Howard County Health Department

FOR PERCOLATION TESTING AND SITE EVALUATION

Re: Confirm Septic Repair Area
7402 Cherry Tree Drive

SITE INSPECTION SHEET

LOCATION DIAGRAM

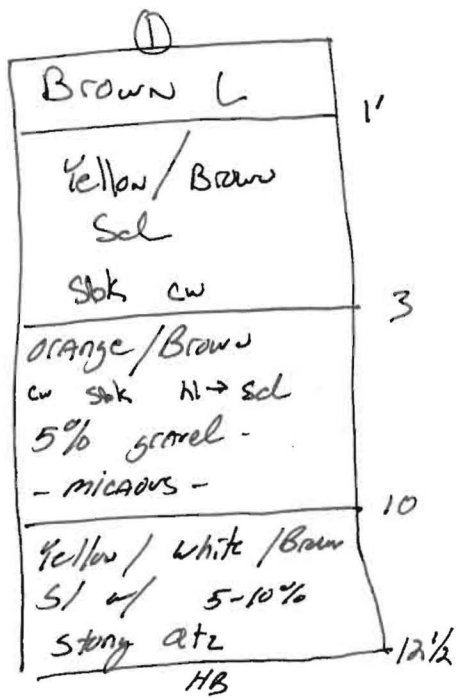
COMMENTS: wells downslope, not to exceed existing shed w/ septic.

-trench specs → Inlet at 4' - max bottom 11' - eff. area 7' - Area not found for a new Bedroom for repair only!
